RFP# 2020-0220-PW/CW
Construction Services for the Canoncito-Eldorado Waterline Project

ADDENDUM #2
*****ADDITIONAL INFORMATION *****

HONDO 2 PUMP STA.
FIRE STORAGE TANK - PLAN

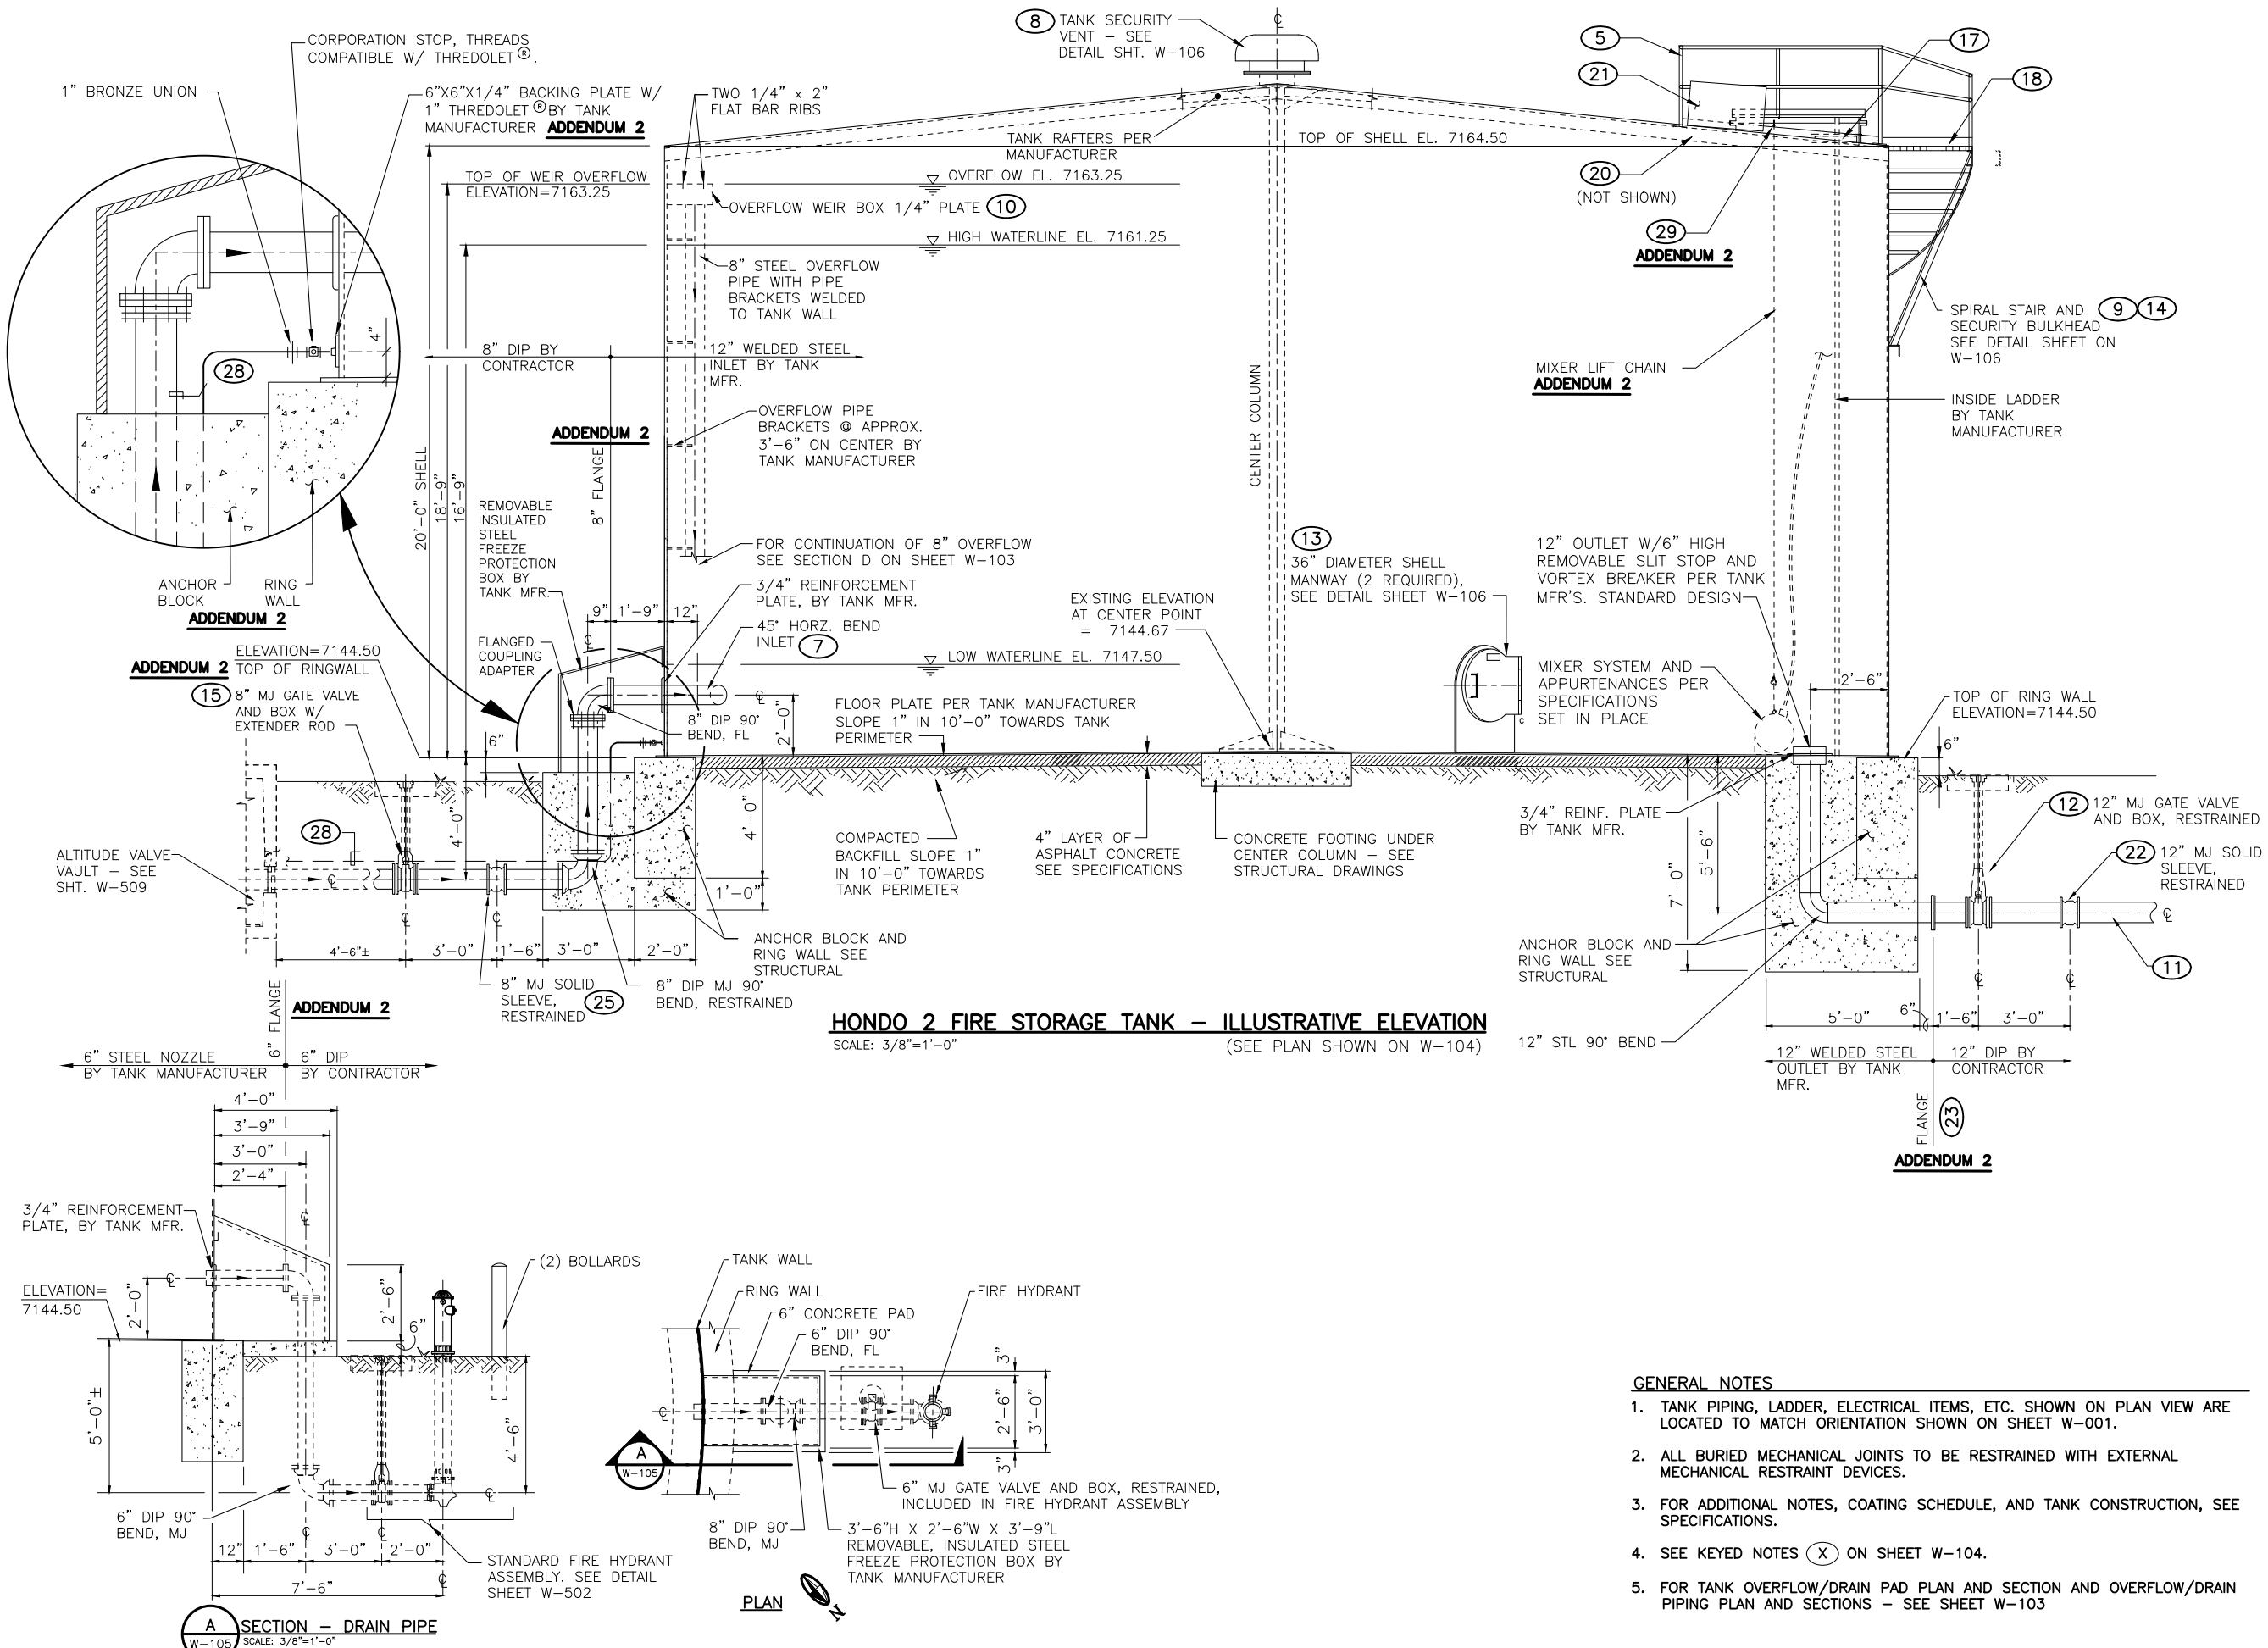
- 1 8" INLET PIPE SEE ILLUSTRATIVE SECTION SHEET W-105
- 2 12" SUCTION PIPE TO BOOSTER STATION. SEE ILLUSTRATIVE SECTION SHEET W-105
- 3 8" TANK OVERFLOW PIPE SEE DETAILS SHEETS W-103
- 4 8" TANK DRAIN LINE & GV.
- 5 TOP HATCH W/ GUARDRAILS SEE SHEET W-105 & W-106
- 6 STAIR LANDING SEE SHEET W-107
- 7 8" STEEL INLET PIPE W/ 45° BEND @ END SEE SHEET W-105
- 8 TANK SECURITY VENT, SEE SHEETS W-105 AND W-106
- 9 SPIRAL STAIR TREAD DETAIL SEE SHEET W-107
- 10 OVERFLOW WEIR BOX SEE SHEET W-105
- 11 12" DIP TO BOOSTER PUMPS **ADDENDUM 2**
- 12 12" GV W/ VALVE BOX

- 13 36" DIA. MANWAY, SEE SHEET W-105 & W-106
- 14 SECURITY BULKHEAD DETAIL SEE SHEET W-107
- 15 8" GV W/ VALVE BOX SEE SHEET W-105
- 16 ALUMINUM ACCESS HATCH, 4'-0"x 4'-0", SINGLE LEAF, SPRING ASSIST, SLAM LOCK W/ PAD LOCK HASP. 4" MINIMUM CURB HEIGHT, 2" COVER OVERLAP OVER CURB, BILCO TYPE SS, OR ENGINEER REVIEWED EQUIVALENT. SHEET W-106 **ADDENDUM 2**

- 29 PROVIDE STAINLESS STEEL HOOK ON INSIDE OF HATCH FRAME TO HOLD END OF MIXER LIFT CHAIN. **ADDENDUM 2**

5/8" SINGLE SERVICE DETAIL - FOR INFORMATIONAL PURPOSES - ADDENDUM 2

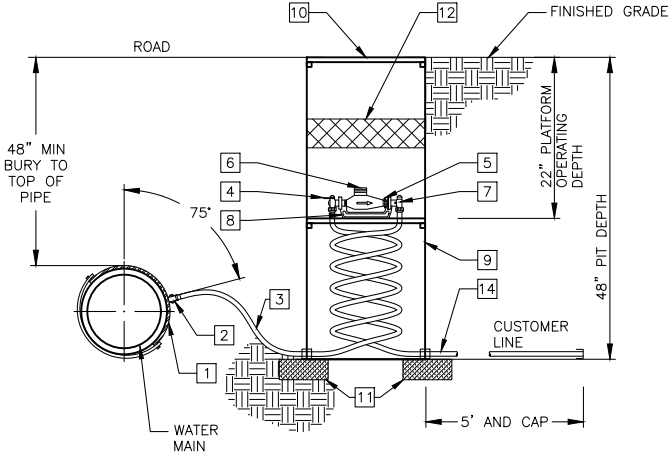
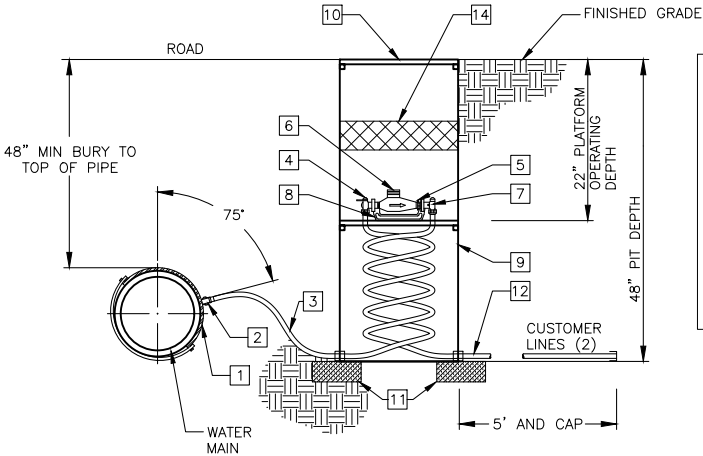
5/8" SINGLE SERVICE DETAIL	
ITEM	ITEM
1. 3/4" SERVICE SADDLE : SEE C.23	8. 3/4" CAST IRON METER YOKE : SEE C.17
2. 3/4" CORPORATION STOP : SEE C.22 (A.W.W.A. TAPERED THREAD)	9. 15" DIAMETER x 48" DEEP THERMAL COIL METER PIT FOR ONE 5/8" X 3/4" METER, 3/4" MIP INLET AND OUTLET CONNECTIONS, FORD METER BOX COMPANY, MUELLER COMPANY, OR ENGINEER REVIEWED EQUIVALENT. ADDENDUM 2

5. 3/4" EXPANSION CONNECTION : SEE C.20 (5/8" X 3/4" M.T.R. CONNECTION)	12. 6" THICK CLOSED CELL FOAM INSULATING DISC WITH LIFTING STRAP. ADDENDUM 2
6. 5/8" X 3/4" NEPTUNE T-10 WATER METER W/E-CODER R900/ REGISTER AND RADIO TRANSMITTER	13. NOT USED. ADDENDUM 2

5/8" DOUBLE SERVICE DETAIL	
ITEM	ITEM
1. 1" SERVICE SADDLE : SEE C.23	8. 3/4" CAST IRON METER YOKE (2 EACH) : SEE C.17
2. 1" CORPORATION STOP : SEE C.22 (A.W.W.A. TAPERED THREAD)	9. 15" DIAMETER x 48" DEEP THERMAL COIL TANDEM METER PIT FOR TWO 5/8" X 3/4" METERS, 3/4" MIP INLET AND OUTLET CONNECTIONS, FORD METER BOX COMPANY, MUELLER COMPANY, OR ENGINEER REVIEWED EQUIVALENT. ADDENDUM 2

7. 3/4" ANGLE CARTRIDGE W/DUAL CHECK VALVE: (2 EACH) SEE C.19	14. 6" THICK CLOSED CELL FOAM INSULATING DISC WITH LIFTING STRAP. ADDENDUM 2

MASTER METER VAULT DETAIL		
APPROVED BY:	REVIEWED BY: S. MORROW	SHEET : W-510
DATE: FEBRUARY 2020		
DRAWN BY: P. DE LA ROSA

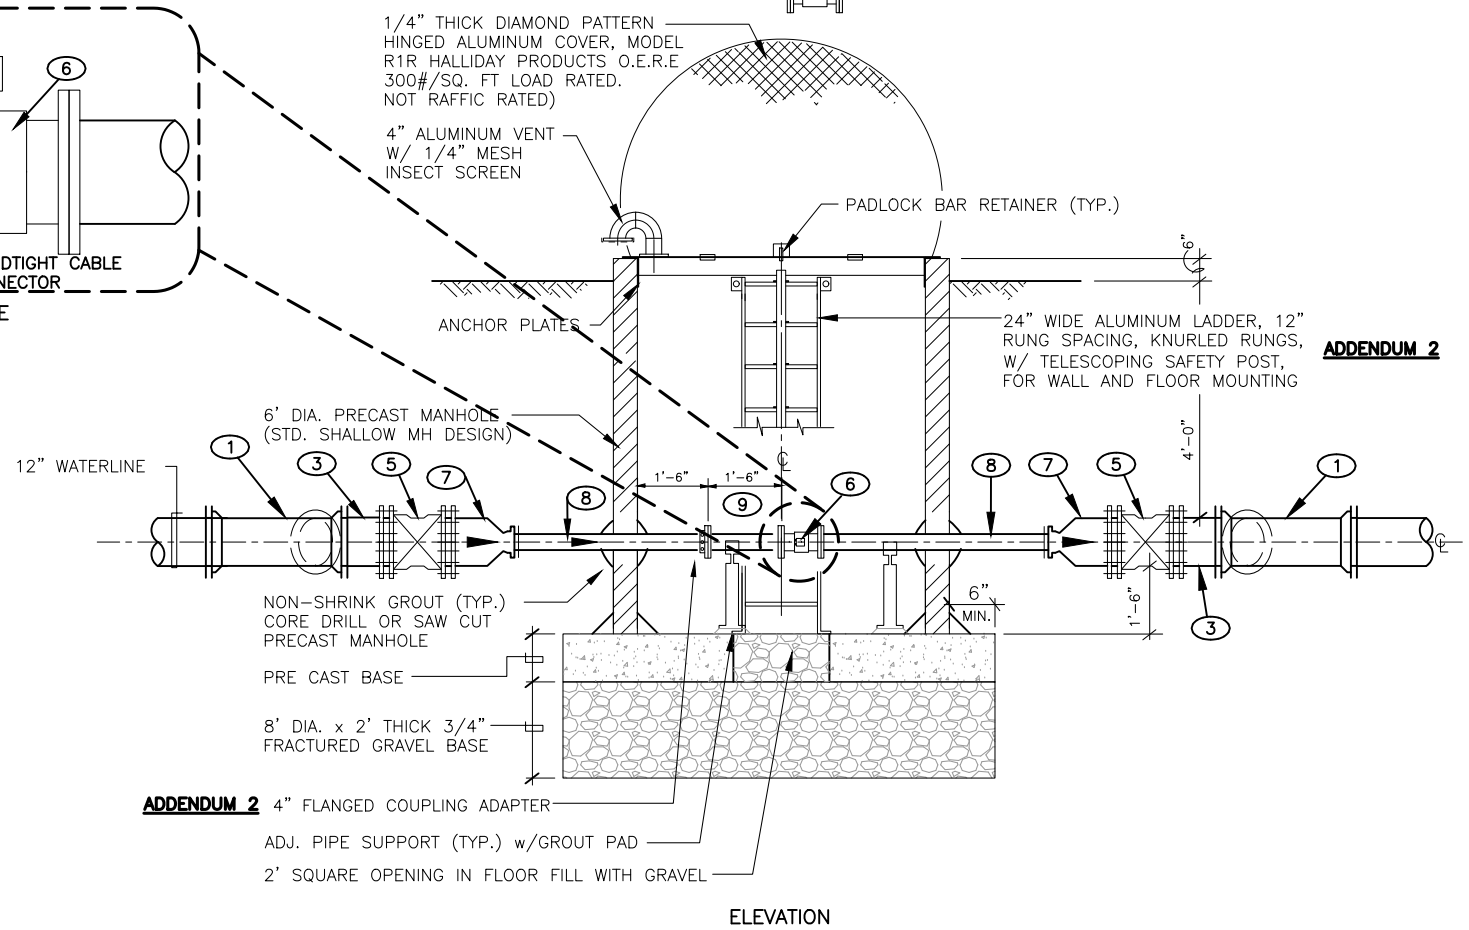
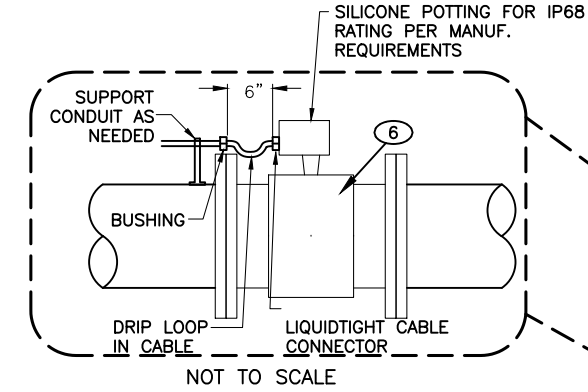
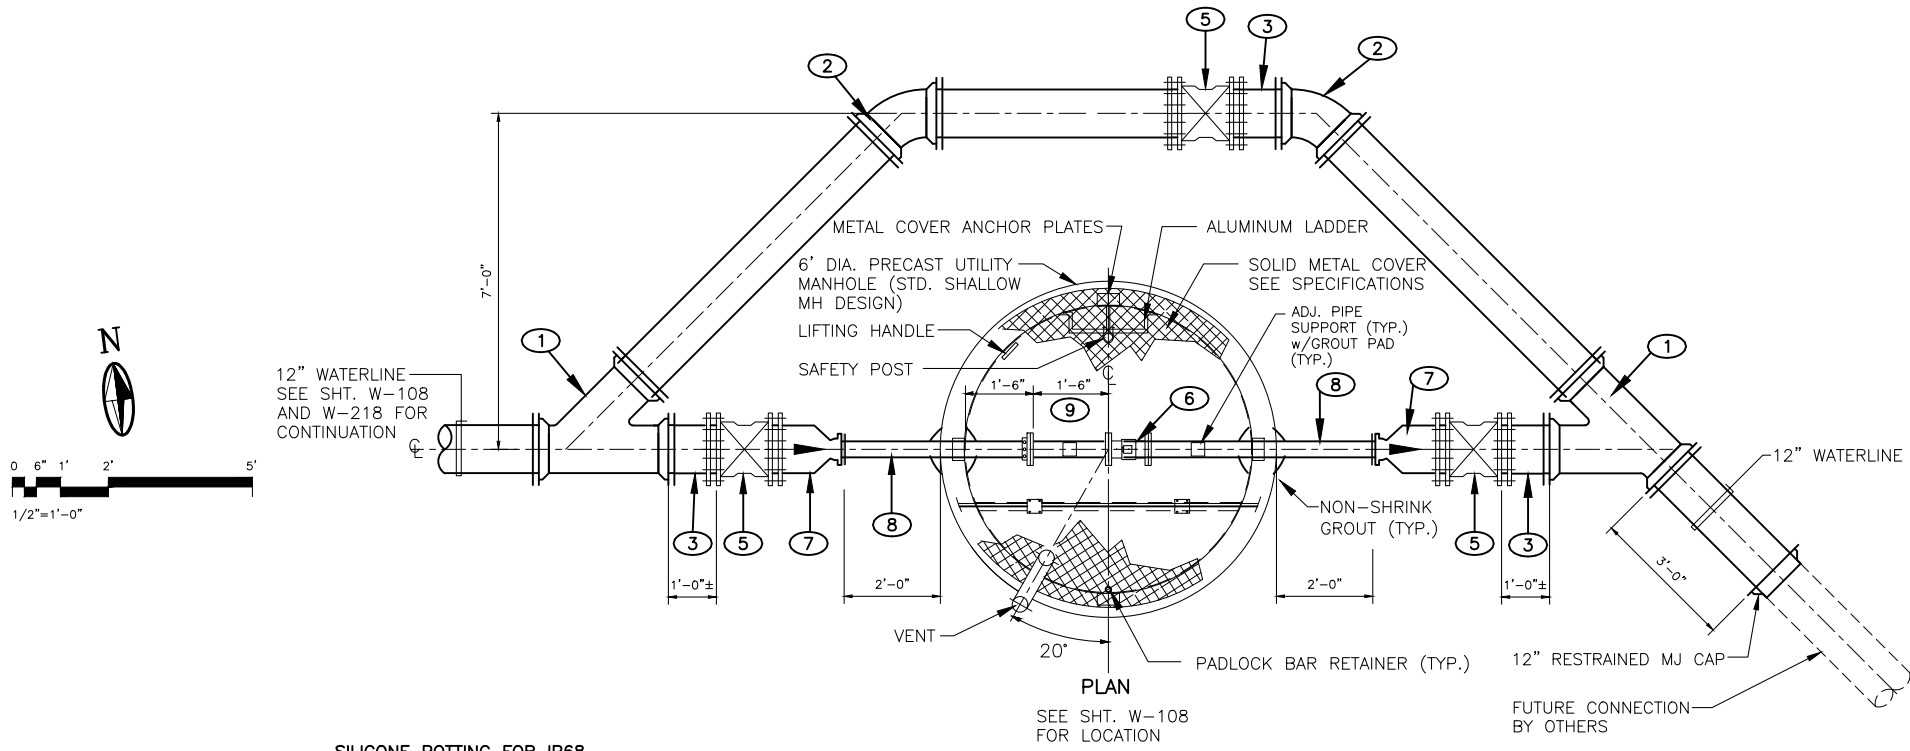
5. Sheet W-510 Note 8. Note is called out on the drawings, but no description.
 - a. **Reissue of Drawing W-510 with this Addendum.**
6. Bid Items 1.08, 2.04, and 3.09. Is there a location where excavated rock can be disposed of?

HORIZONTAL DIRECTIONAL DRILL AND
JACK AND BORE STANDARD DETAIL

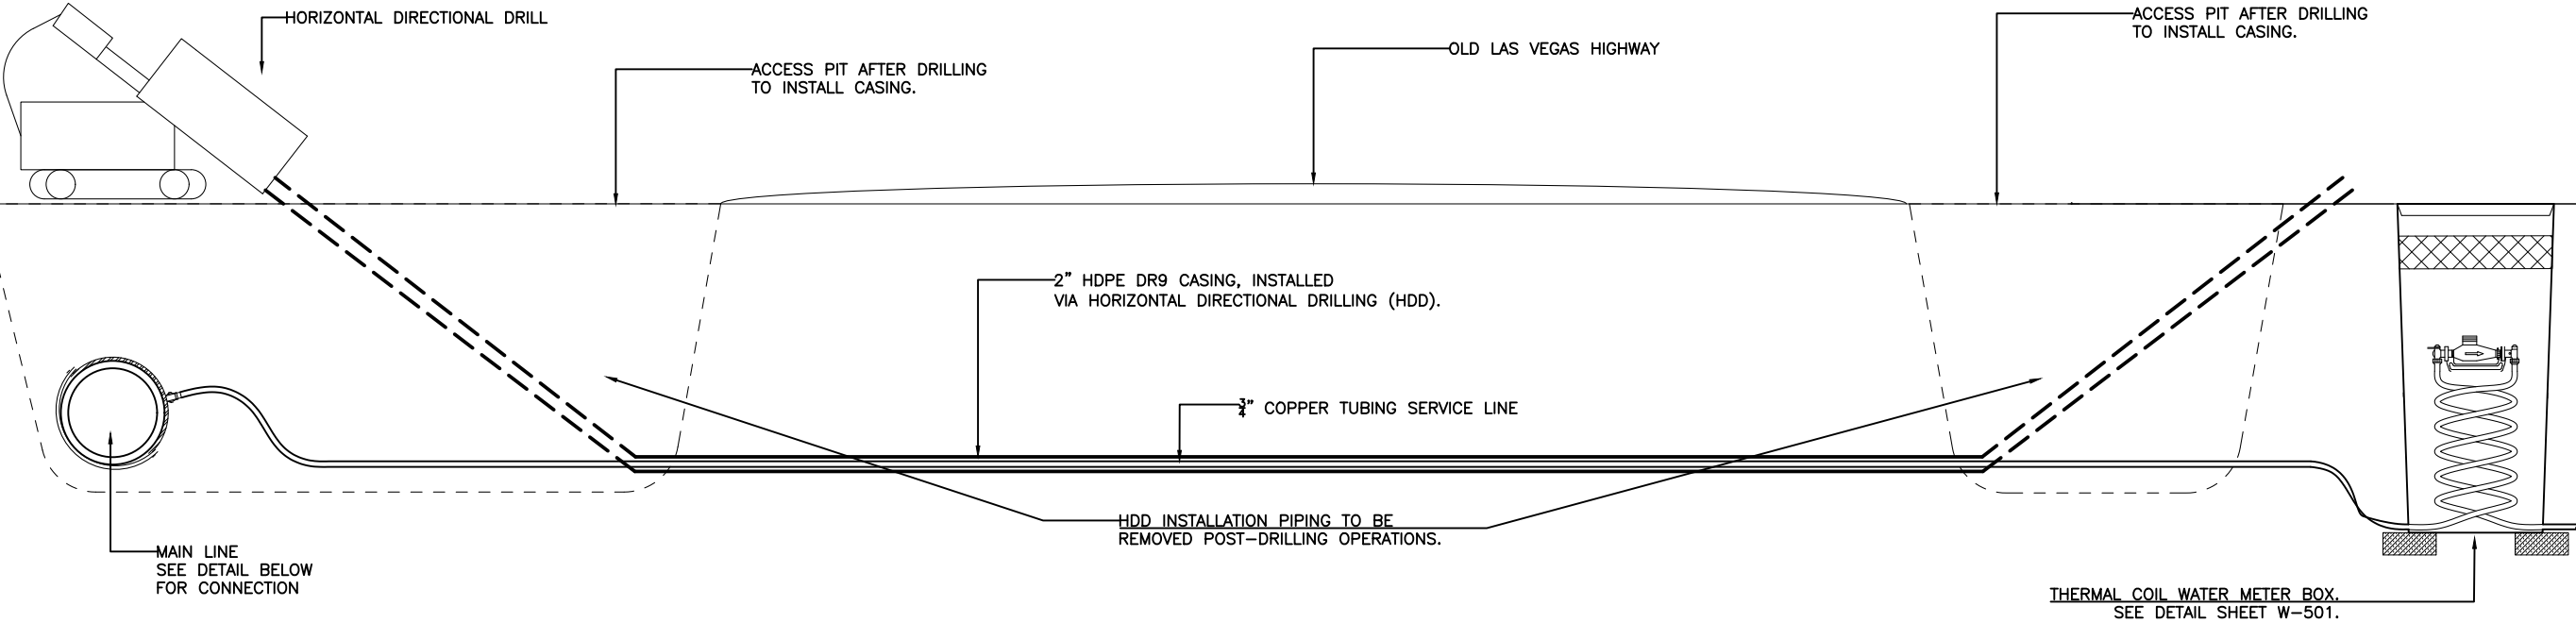
- 35. Sheet W-511 HORIZONTAL DIRECTIONAL DRILL AND JACK AND BORE STANDARD DETAILS – updates to tracer wire detail.
 - a. **Reissue of Drawing W-511 with this Addendum.**

APPROVED BY:	REVIEWED BY: S. MORROW
DATE: FEBRUARY 2020	SHEET :
DRAWN BY: A. TRUJILLO	W-513

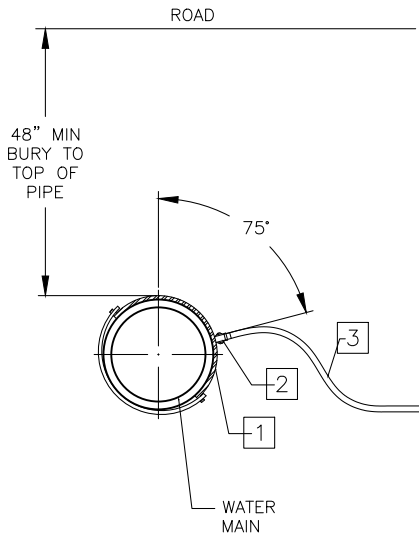
10. HDD Bid Items. Is there a location where drill cuttings can be disposed of?
 - a. **Contractor is responsible for disposal of waste material.**
11. Bid Item 3.18 Will there be a casing for this work? If so what size and material?

- a. **Issue of new drawing W-513 of HDD crossing detail with this Addendum.**
12. Where can grubblings from site clearing be disposed of?
 - a. **Contractor is responsible for disposal of waste material.**
